Name: Stephen van Staden
Date: Thursday, 18 November 2021
Ref: FEN 20-2115

MEMORANDUM: FRESHWATER SPECIALIST OPINION REGARDING THE UPDATED LAYOUT FOR THE PROPOSED RIETKLOOF WIND ENERGY FACILITY (WEF), BETWEEN SUTHERLAND AND MATJIESFONTEIN IN THE WESTERN CAPE PROVINCE

Figure 1: The conceptual presentation of the July 2021 Rietkloof WEF layout relative to the delineated watercourses and the respective legislative Zones of Regulation as it relates to NEMA and NWA.

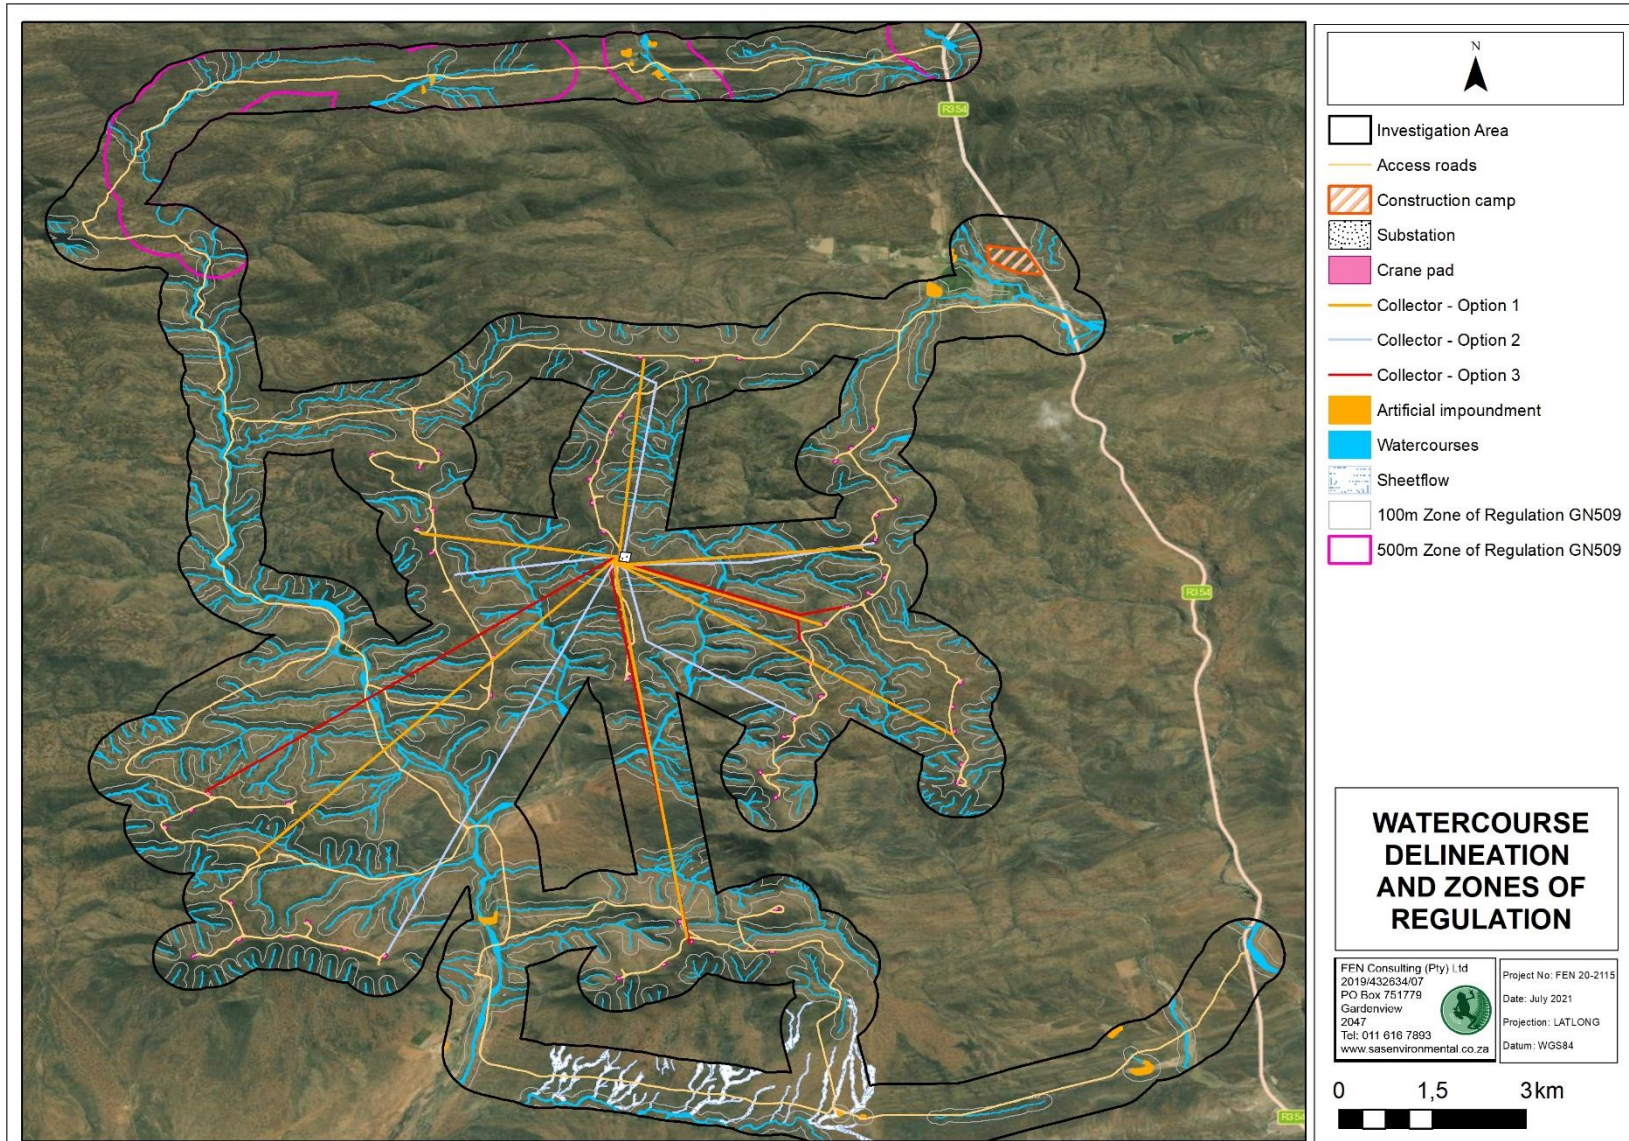
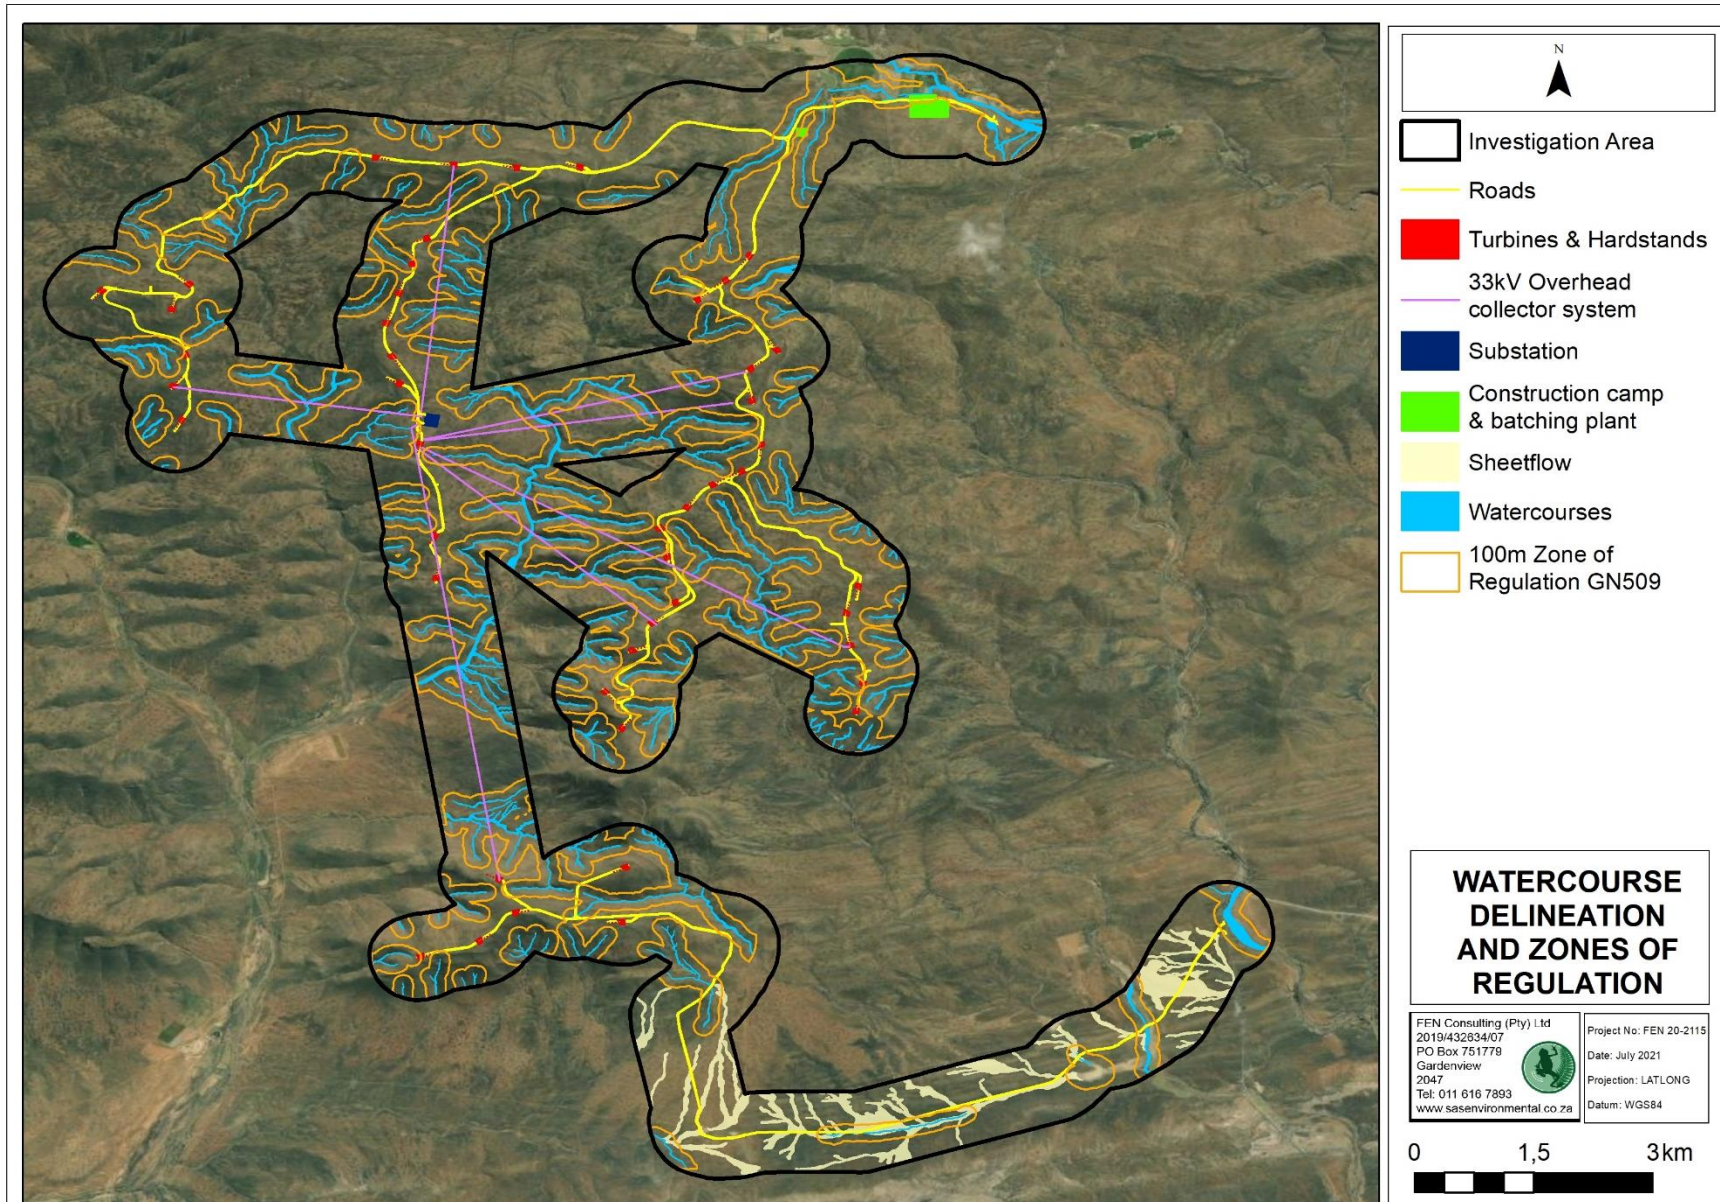
The table below provides a concise comparison of the updated layout (November 2021) versus the July 2021 assessed layout relative to watercourses. The layouts are also visually presented in Figure 1 and 2 in Appendix A.

Proposed surface infrastructure component	Layout as per FEN Consulting (July 2021) (Appendix 1, Figure 1)	Updated layout (November 2021) (Appendix 1, Figure 2)
Construction camp	48 m from the Roggeveld River (thus within the 100m GN509 Zone of Regulation)	Located immediately south of a drainage line, however, a section of the construction camp/laydown area will be located within the existing Roggeveld WEF batching plant footprint, thus no additional impacts are expected. Batching plant located approximately 58 m from a watercourse. Overall impact is reduced
Turbines and Crane pads	Total: 60 turbines and associated hardstands <ul style="list-style-type: none"> • Crane pad associated with Turbine 59, located approximately 79 m from a watercourse. • Crane pad associated with Turbine 63, located approximately 88 m from a watercourse. • Crane pad associated with Turbine 48, located approximately 75 m from a watercourse. • Crane pad associated with Turbine 49, located approximately 99 m from a watercourse. 	Total: 47 turbines and associated hardstands <ul style="list-style-type: none"> • Crane pad associated with Turbine 17, located approximately 79 m from a watercourse. • Crane pad associated with Turbine 28, located approximately 30 m from a watercourse. • Crane pad associated with Turbine 44, located approximately 96 m from a watercourse. • Crane pad associated with Turbine 69, located approximately 50 m from a watercourse.

Access roads	<ul style="list-style-type: none"> • Several watercourse crossings (new and existing). • Upgrading of extensive sections of the proposed access roads which are located adjacent to wetlands and the Groot River. 	<ul style="list-style-type: none"> • Several watercourse crossings (new and existing), noted to be less than what was proposed in the July 2021 road layout. • Upgrading of extensive sections of the proposed access roads which are located adjacent to the Groot River, thus reducing impact and risk - no wetlands will be traversed

It is noted that the updated November 2021 layout will pose a negligible quantum of risk to any wetlands since all infrastructure components are located outside the delineated wetlands and their associated 500 m Zone of Regulation (ZoR) in accordance with Government Notice 509 as published in the Government Gazette 40229 of 2016 as it relates to activities as stipulated in Section 21(c) and (i) of the National Water Act, 1998 (Act No. 36 of 1998) (NWA). Additionally, no extensive sections of roads will be constructed along the major rivers (with specific mention of the Groot River). This has significantly reduced the significance of any potential impacts of the proposed development on the identified watercourses. As such, the risk significance of the updated November 2021 layout is considered ‘Low’. Nonetheless, roads will still cross smaller watercourses which will result in direct negative impacts to the watercourses. It is the opinion of the ecologist that formalising watercourse crossings with appropriate through flow structures is considered advantageous over the long-term as existing informal watercourse crossings have resulted in erosion of the watercourses which have caused interruption of hydrological connectivity between the upstream and downstream reaches.

As such, although the outcome of the DWS Risk Assessment as per the freshwater ecological assessment (FEN Consulting, 2021) indicated a ‘Moderate’ risk significance, the updated November 2021 layout entails less watercourse crossings and avoids any wetlands and their applicable 500 m ZoR, which results in a reduced (Low) overall risk significance. It is recommended that the mitigation measures as provided in the freshwater ecological assessment (FEN Consulting, 2021) be implemented

It can be concluded that the updated November 2021 layout of the proposed Rietkloof WEF does not pose any additional negative impacts to any watercourses, but rather will generate less impacts and pose less of a risk than the originally assessed layout to the watercourses of the region. The FEN Consulting (2021) freshwater ecological assessment is considered applicable, acceptable and appropriately accurate and comprehensive to inform the required legislative processes for the proposed Rietkloof WEF authorisation and subsequent development when read in conjunction with this Memorandum.
